PIC16C773 Rev. B Silicon Errata Sheet

The PIC16C773 (Rev. B) parts you have received conform functionally to the Device Data Sheet (DS30275A), except for the anomalies described below.

Clarifications/Corrections to the Data Sheet:

FIGURE 15-1: PIC16C773/774 VOLTAGE-FREQUENCY GRAPH, $-40^{\circ}\text{C} \leq T_A \leq +85^{\circ}\text{C}$

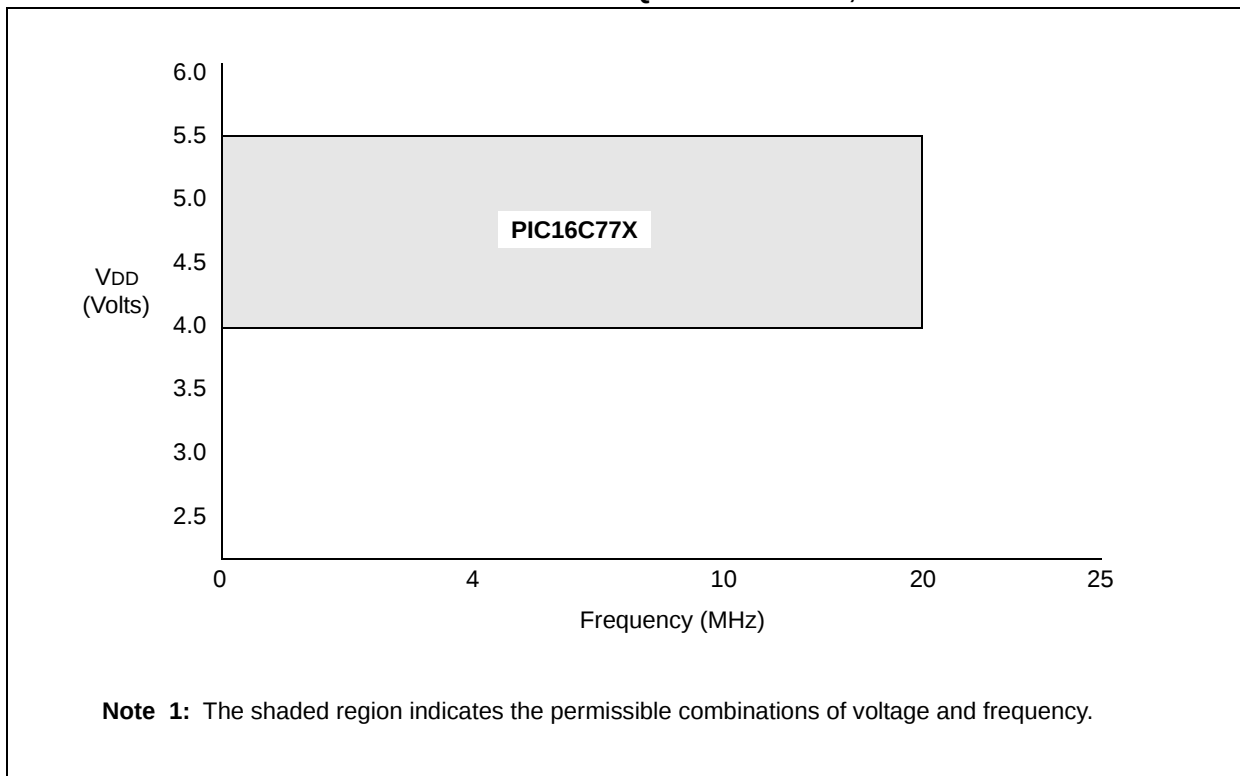
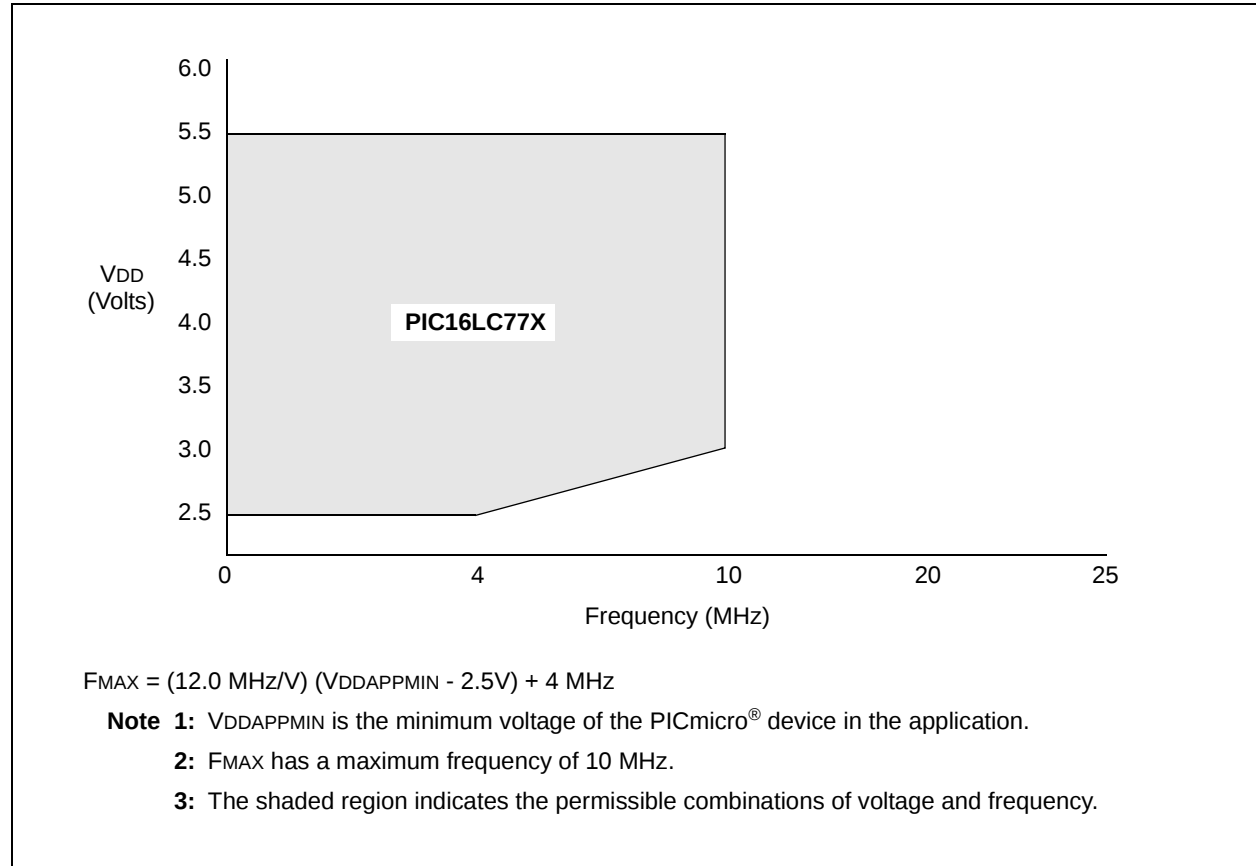
1. Table 15-1 in the Device Data Sheet (DS30275A) should be omitted. Figure 15-1 and Figure 15-2 below should be used to determine the operating voltages and frequencies for the devices.

FIGURE 1: A/D CLOCK SOURCE BLOCK DIAGRAM

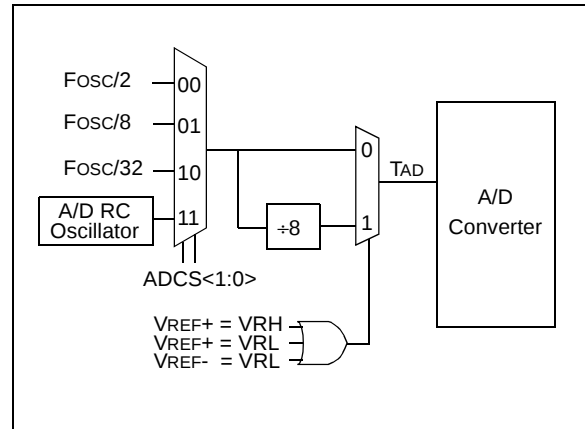
8. The A/D clock source bits (ADCS1:ADCS0) have had their operation modified. See Register 1 for a new definition of the ADCS1 and ADCS0 bits.

Figure 1 shows how the TAD time is determined based upon the selection of the ADCS<1:0> bits and the source of VREF+ and VREF-. When VREF+ or VREF- comes from the internal voltage reference (VRH or VRL), then the required TAD time is increased by a factor of eight (see electrical specification parameter #130A).

The clock source selected by the ADCS<1:0> bits is divided by eight when an internally generated reference voltage is used as reference to the A/D module. This automatically addresses the requirement for the TAD time when the internal voltage reference is used as the A/D voltage reference.
